**Re: Auto Zone/ 9510 Universe Blvd NW
Request for Certificate of Occupancy
Transportation Development Final Inspection
Engineer's Stamp dated 01-28-25 (B10D003C3A)
Certification dated 12-23-25
TRANS-2025-00369**

**RE: AA Approved Site Plan
Request for Final Certificate of Occupancy
Auto Zone 9510 Universe NW
B10D003C3A (TRANS-2025-00125)**

ENGINEER'S SEAL AUTOZONE #9260 PASEO DEL NORTE & UNIVERSE BLVD SITE PLAN	DRAWN BY RMG DATE 01/28/2024 SHEET # C1
	01/28/2025 RONALD R. BOHANNAN P.E. #7868	TERRA WEST, LLC 5571 MIDWAY PARK PLACE NE ALBUQUERQUE, NM 87109 (505) 858-3100 www.tierrawestllc.com

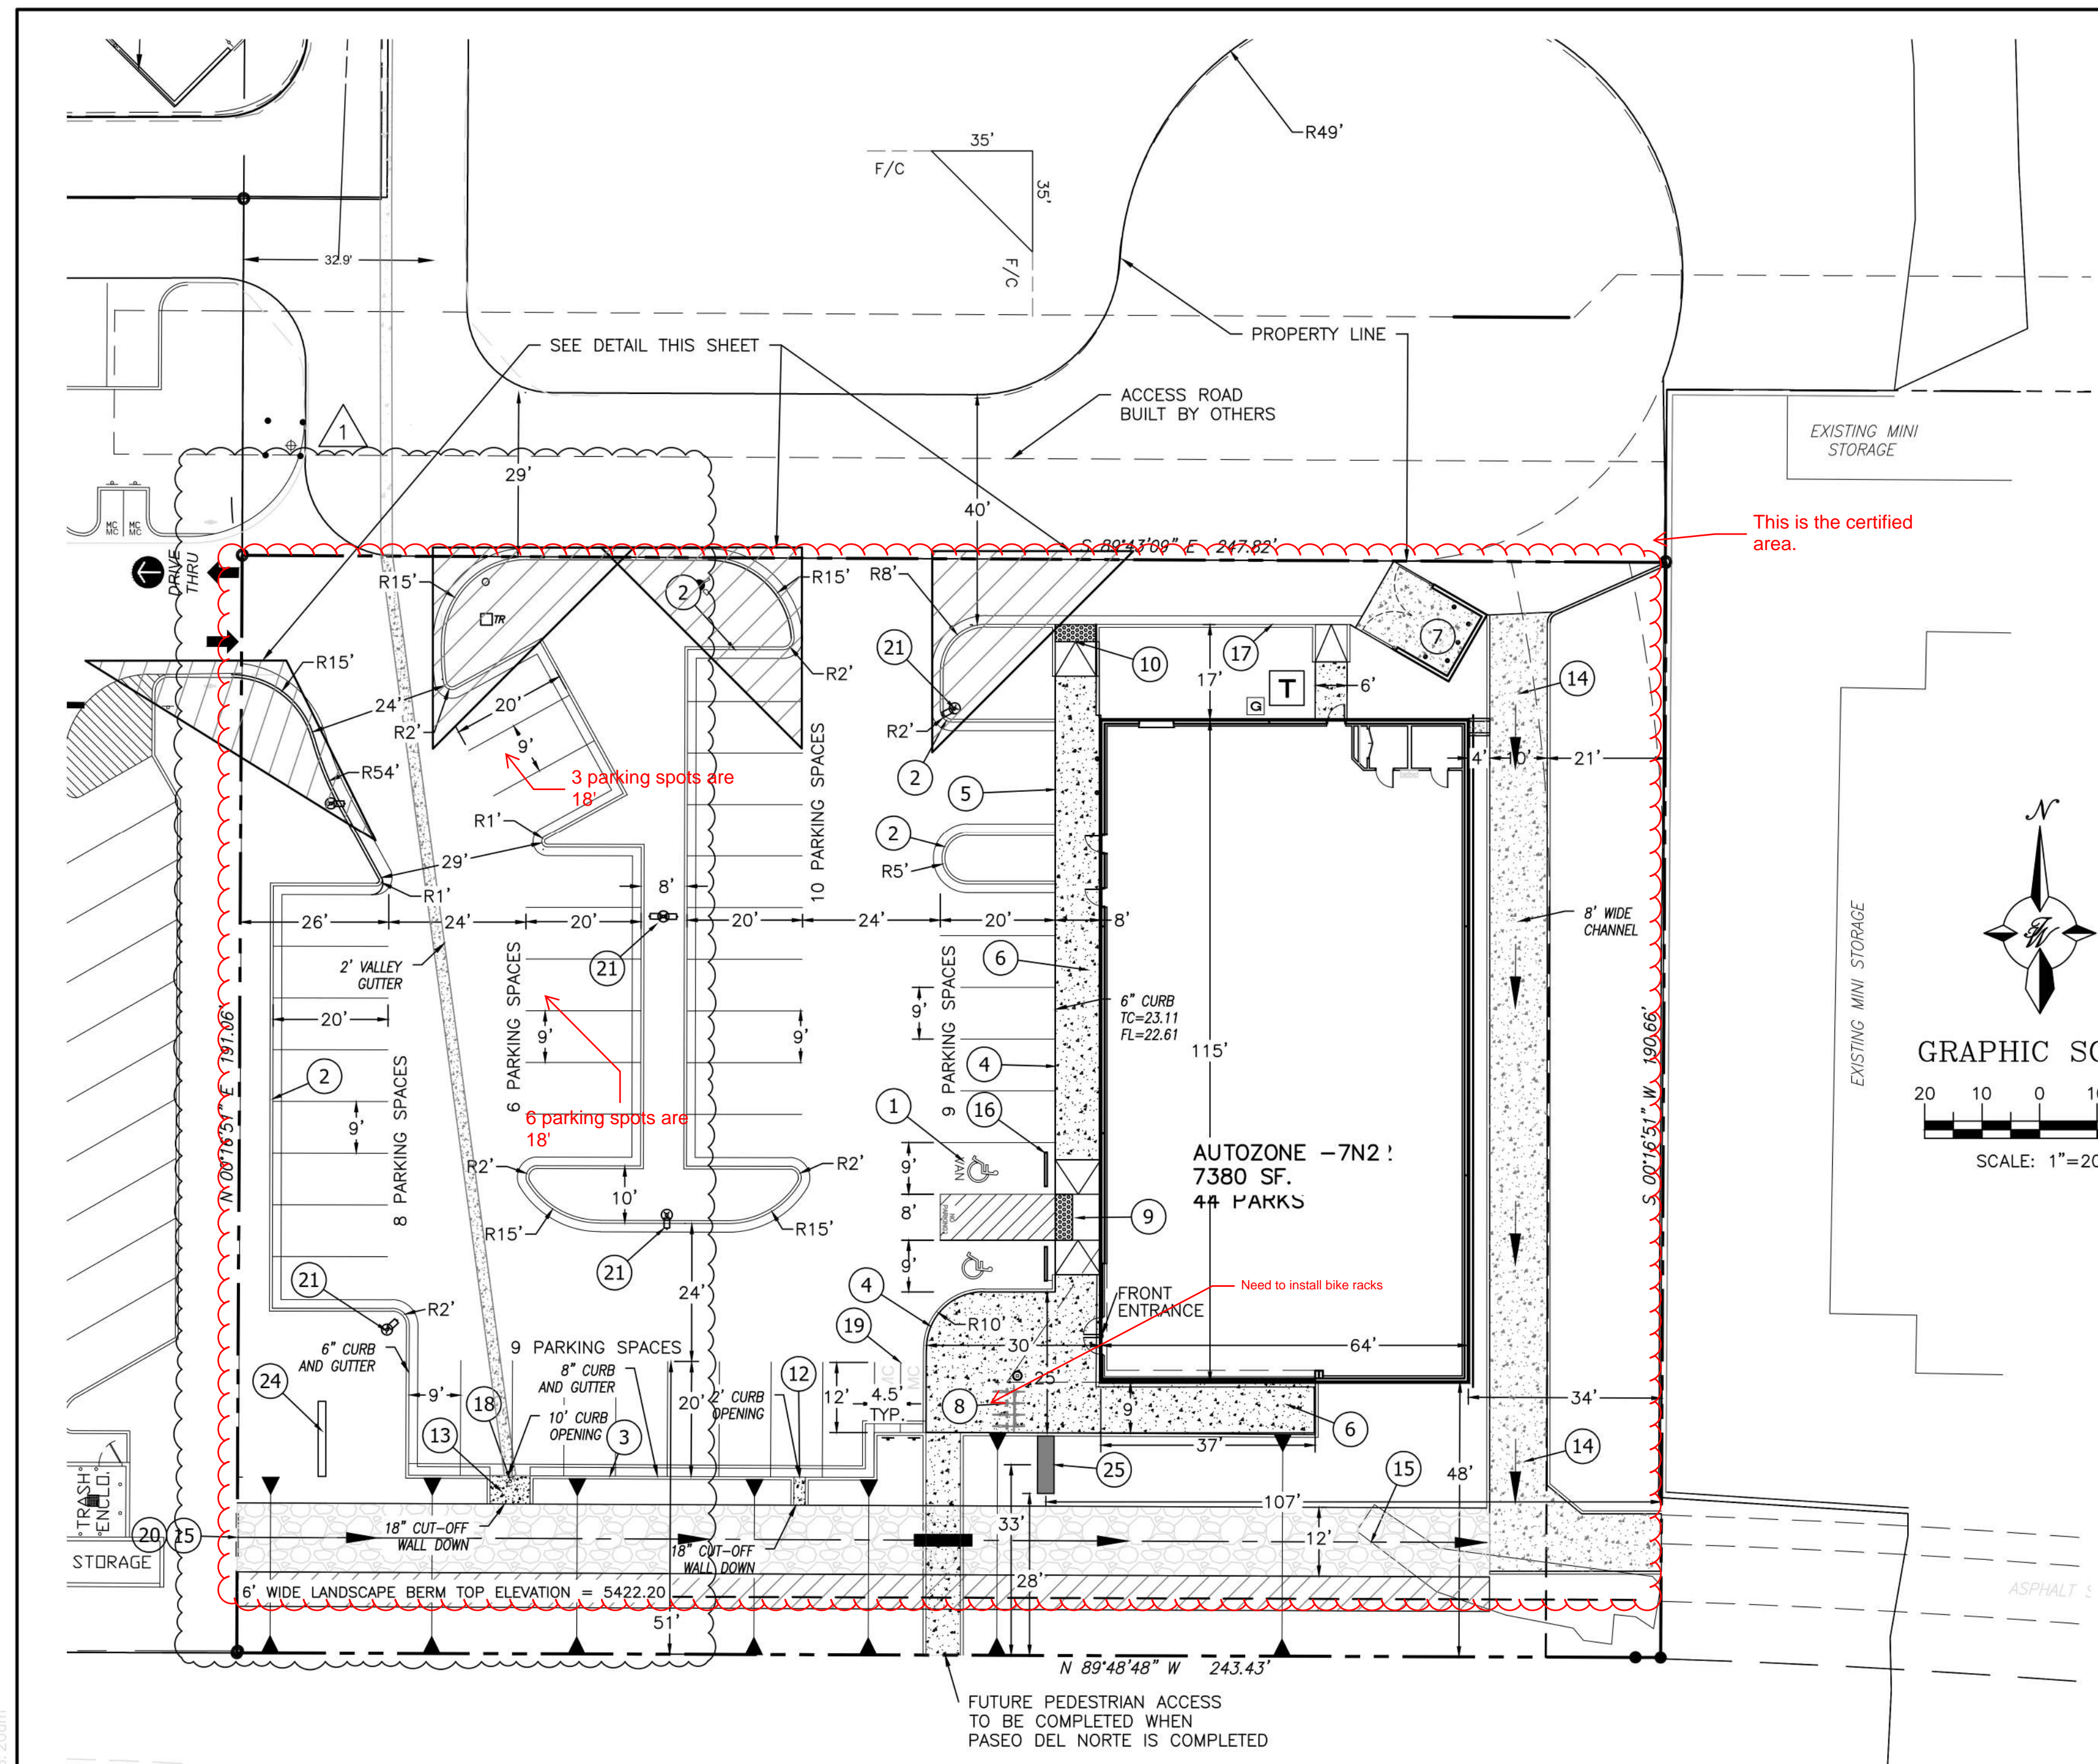
Based upon the information provided in your submittal received 12-29-25, Transportation Development has no objection to the issuance of a Permanent Certificate of Occupancy. This letter serves as a "green tag" from Transportation Development for a Permanent Certificate of Occupancy to be issued by the Building and Safety Division. **ONCE THE PUBLIC SIDEWALK OR MULTI USE TRAIL IS CONSTRUCTED ALONG PASEO DEL NORTE, THE ADA PATHWAY FROM THIS PUBLIC SIDEWALK TO THE BUILDING ENTRANCE SHALL BE CONSTRUCTED.**

I, Ronald R. Bohannon, NMPE #7868, of the firm Tierra West LLC, hereby request approval of the as-built Approved Site Plan for Building Permit for issuance of a Permanent Certificate of Occupancy for the project referenced above. This project area as highlighted on the attached site plan is in substantial compliance as inspected on December 23, 2025, and is in general accordance with the design intent of the Approved AA Site Plan for Building Permit dated 1-28-25. Nine of the spaces were changed from 20 feet in depth to 18 feet and are noted. Also the bike rack is on site and is being installed but was not mounted at the time of inspection.
